**TOWN OF NEWBURGH
PLANNING BOARD
REVIEW COMMENTS**

PROJECT: LAXMI ESTATES II, LLC
PROJECT NO.: 06-23
PROJECT LOCATION: SECTION 40, BLOCK 2, LOT 20
PROJECT REPRESENTATIVE: BOHLER ENGINEERING
REVIEW DATE: 16 JULY 2013
MEETING DATE: 18 JULY 2013

PROJECT ANALYSIS

MUNICIPALITY: TOWN OF NEWBURGH TOWN PROJECT NO. 2006-23
PROJECT NAME: Laxmi Estate II, LLC
LOCATION: 5277 Route 9W (40-2-20) **SB 20-2-40**
TYPE OF PROJECT: Site plan for a Dunkin Donuts (3900 sq. ft)
DATE: July 11, 2013
REVIEWING PLANNER: Bryant Cocks

SITE PLAN

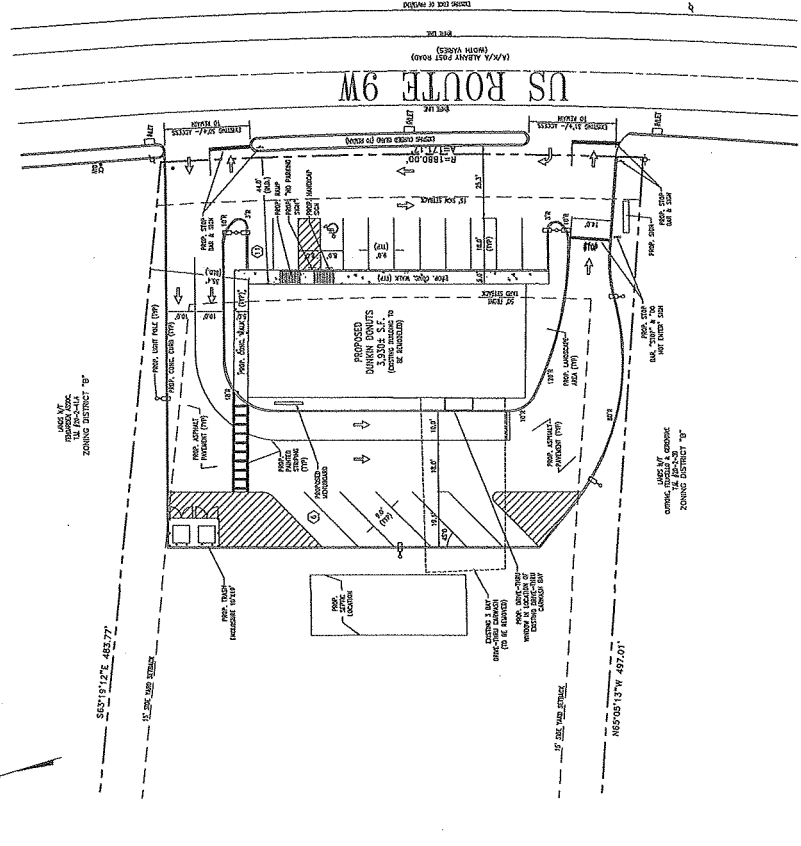
1. NYSDOT review and approval for the site plan is required.
2. County Planning review is required.
3. Front yard setback may require a zoning variance. Building is located within the 50 foot front yard setback.
4. Subsurface Sanitary Sewer Disposal System design must be provided.
5. Site improvement details must be provided.
6. Storm Water Management on the site must be addressed.

2. There is an existing front yard setback violation (50 feet required, 44 existing). The Planning Board previously determined that no variance would be necessary since the setback violation is not increasing.

3. The applicant now proposes a Dunkin Donuts with a drive-thru lane, with the building taking up the whole 3900 square feet of the building. The Planning Board previously reviewed the project for zoning issues, and no variances were necessary. There are several issues in the drive-thru section of the zoning code (185-42) that the Planning Board will need to review before approving the plans, listed below:

- Pedestrian Safety
 - Signage, lighting and speaker noise
 - Vehicle stacking
4. The applicant has currently only shown a conceptual plan for the project, the above items will need to be detailed on the site plan. A lighting and landscaping plan will also need to be submitted. The Planning Board previously was concerned with the landscaping at the back of the site, specifically if the plantings will survive in the existing soil.

5. The lighting on site should meet the Town Design Guidelines in being pedestrian in scale (15 feet) and have a decorative fixture or aesthetic value. All lighting on site, including on the building, should be evaluated in the lighting plan.

6. ARB drawings should also be provided to the Planning Board with color and material samples brought to the next meeting. All architectural features should be labeled on the plans, including specific colors for each façade. The screening of the rooftop HVAC units should also be shown.

7. A signage plan should be submitted showing the allowable amount of signage on site and the total signage for the freestanding and building signs. The applicant was discussing tying the rock wall into the freestanding sign when they were last before the Planning Board. This should be shown on the site plans and landscaping plan.

8. A traffic movement plans should be submitted showing the turning movements of both the garbage trucks and delivery trucks. Where will the delivery trucks park during drop offs since there is no loading zone and parking in back of the site? The largest delivery truck anticipated should be shown on the turning movement plan.

9. The proposed trash enclosure should be detailed in the site plan.
10. A demolition permit will be required for the car wash bay removal.
11. The project received a Local Determination from the Orange County Planning Department in May 2006. The Planning Board should discuss whether the plans should be re-submitted.
